RENESAS TECHNICAL UPDATE

Product Category	MPU & MCU	Document No.	TN-16C-A239A/E	Rev.	1.00
Title	Deletion of Specifications and Errata for R32C/117A Group User's Manual: Hardware		Information Category	Technical Notification	
Applicable Product	R32C/117A Group	Lot No.	Reference Document	R32C/117A Group User's Manual: Hardware Rev. 1.10 (R01UH0214EJ0110)

This document describes deletion of specifications and errata for the R32C/117A Group User's Manual: Hardware, Rev. 1.10.

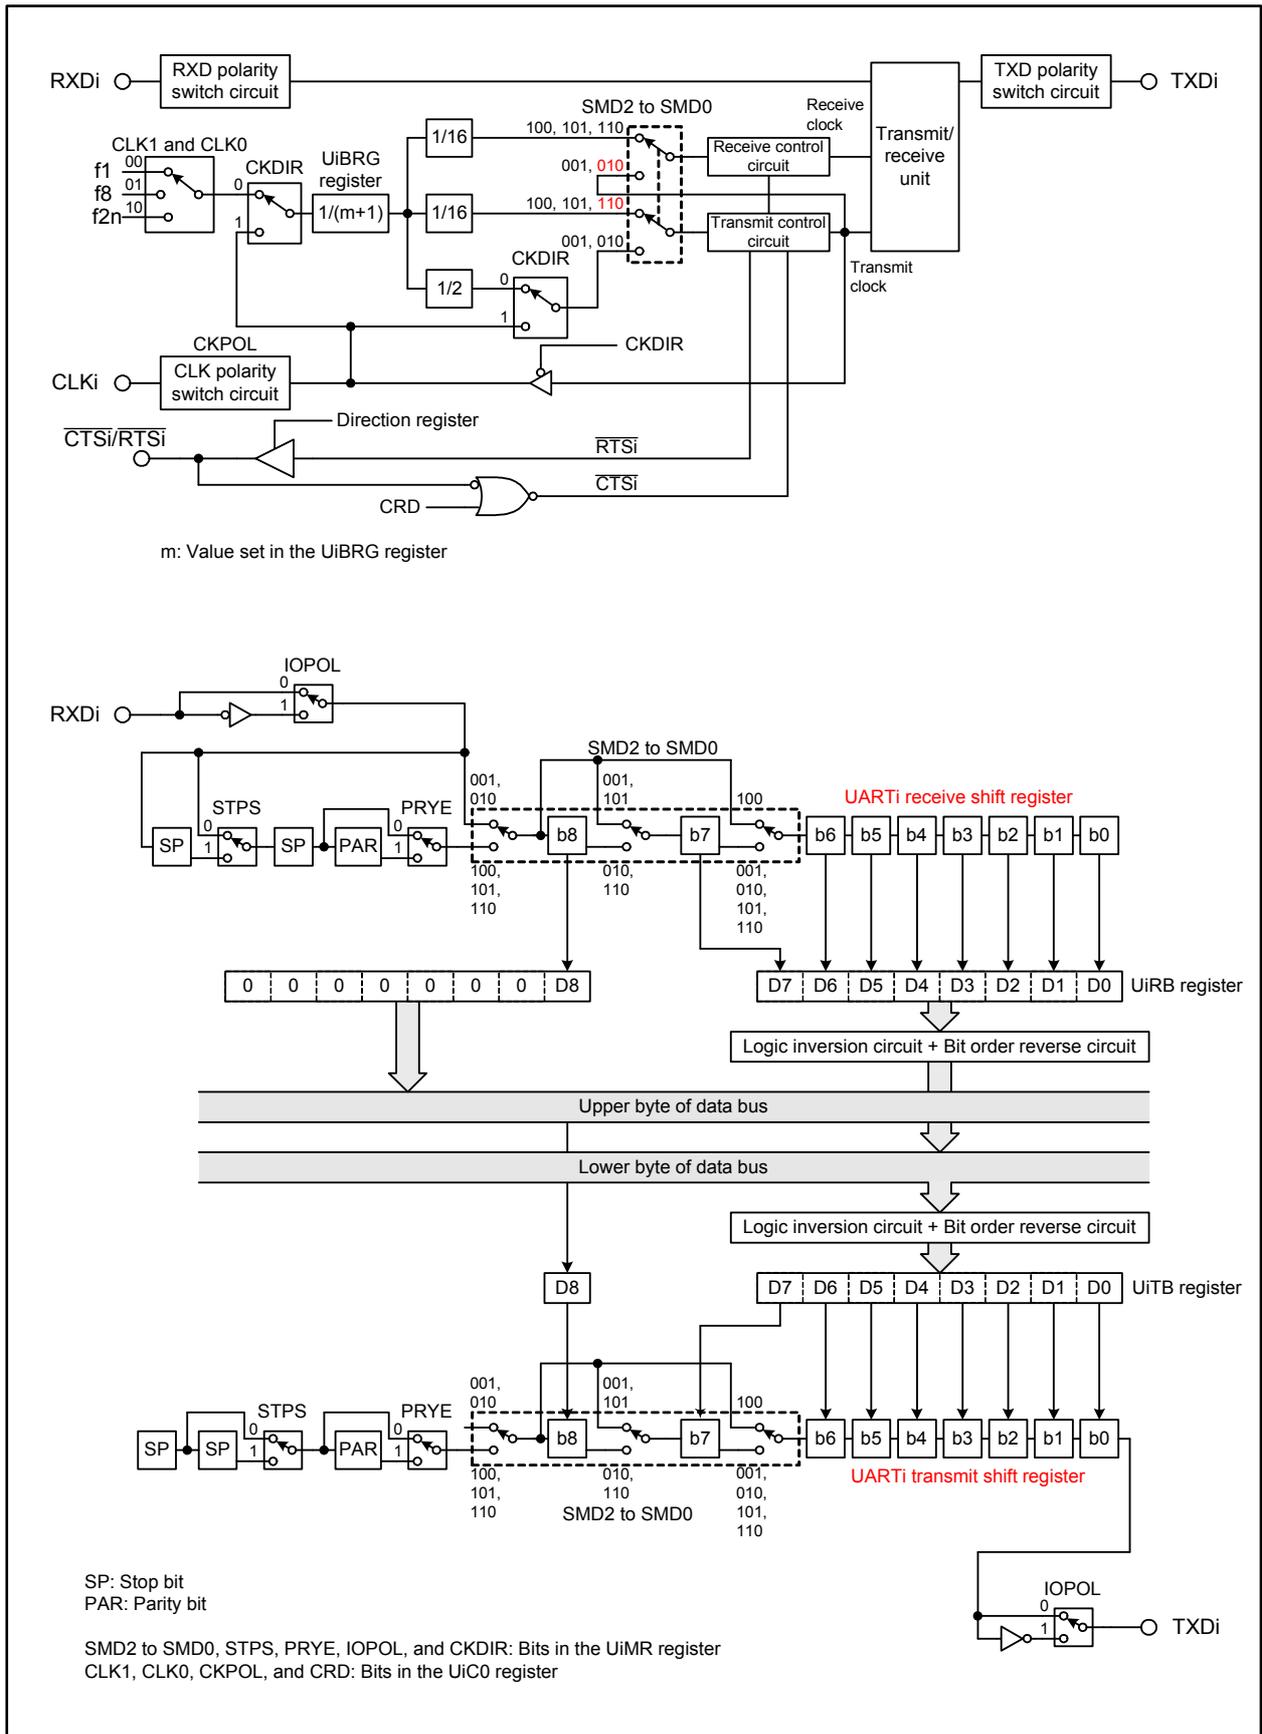
•Page 255 of 625, positions of “010” for bits SMD2 to SMD0 in Figure 18.1 are corrected as follows:

Transmit timing (when selecting an internal clock)

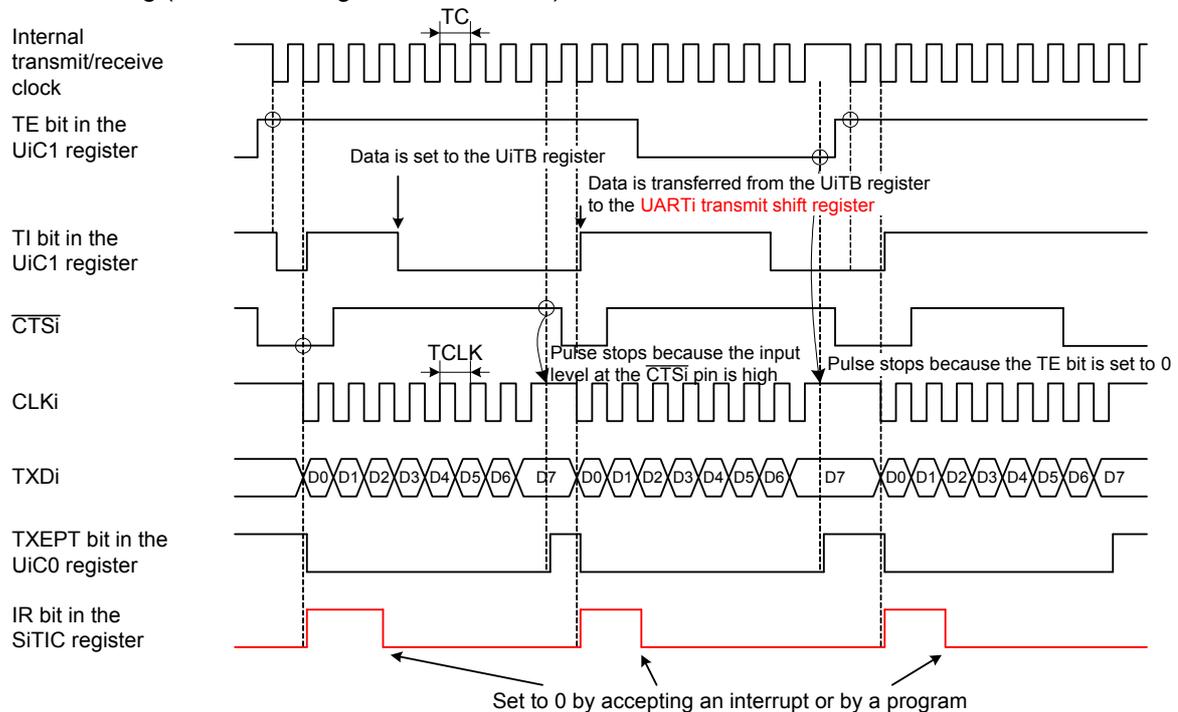
- Page 265 of 625, expression “baud rate generator count source” in the function of bits DL0 to DL2 in Figure 18.13 is corrected as follows:
 “count source for the UiBRG register”
- Pages 272, 273, 280, 281, 290, 300 of 625, descriptions in Function of the UiBRG register in Tables 18.3, 18.4, 18.6, 18.7, 18.10, and 18.15 are modified as follows:
 “Set the divide ratio according to the bit rate”
- Pages 273, 281 of 625, description for (b7 to b4) to registers UiC1 and U78CON in Tables 18.4 and 18.7 is added as follows:
 “(b7 to b4) Set the bits to 0000b”
- Page 274 of 625, waveform of the IR bit in Figure 18.21 is corrected as follows:

This figure applies under the following conditions:

- The CKDIR bit in the UiMR register is 0 (internal clock).
- The CRD bit in the UiC0 register is 0 (CTS function enabled).
- The CKPOL bit in the UiC0 register is 0 (output transmit data on the falling edge of the transmit/receive clock).
- The UiIRS bit in registers UiC1, U78CON, and U910CON is 0 (an interrupt request is generated when the transmit buffer is empty).

$TC = TCLK = 2(m + 1)/fx$
 fx : UiBRG count source frequency ($f1$, $f8$, or $f2n$)
 m : Value setting in the UiBRG register

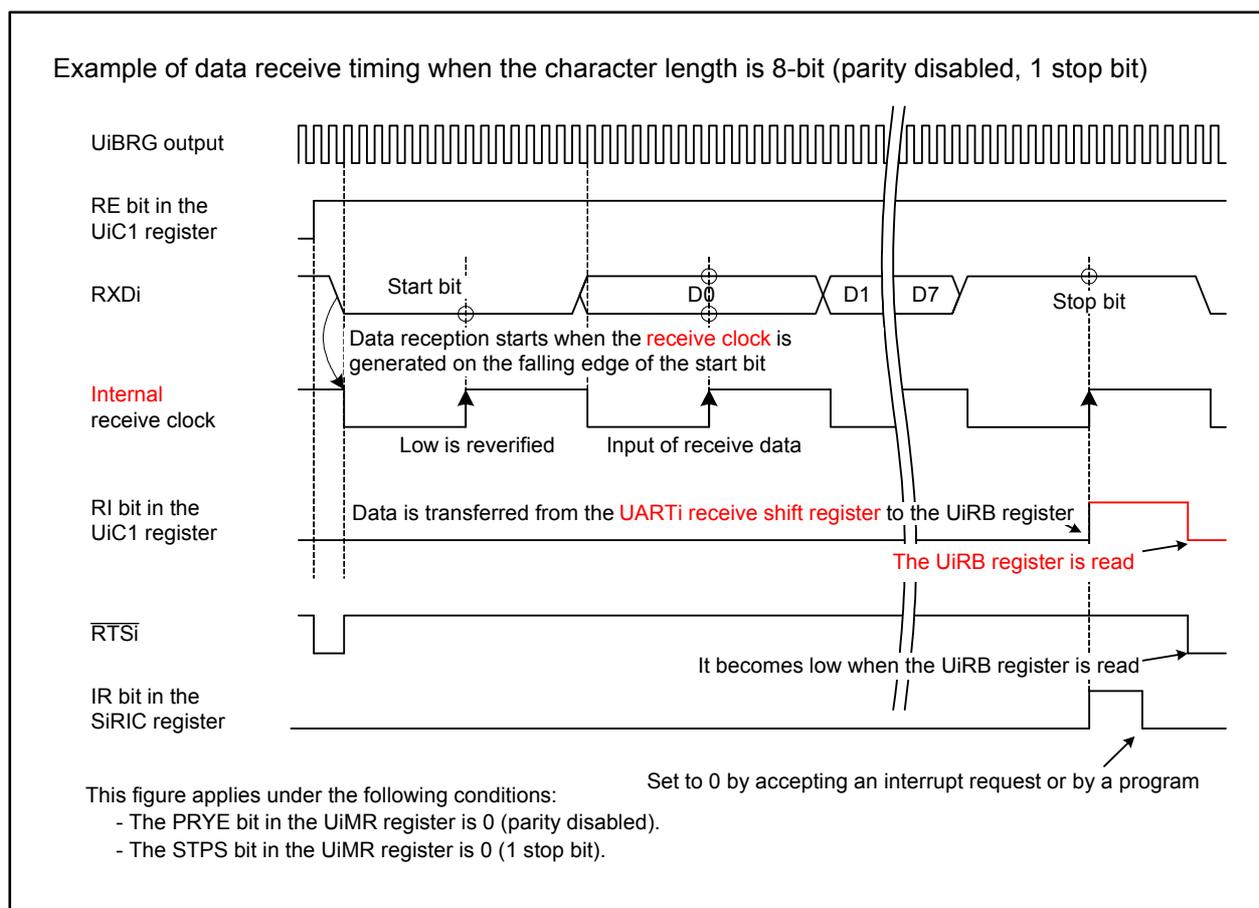
•Page 284 of 625, Figure 18.28 is corrected as follows:
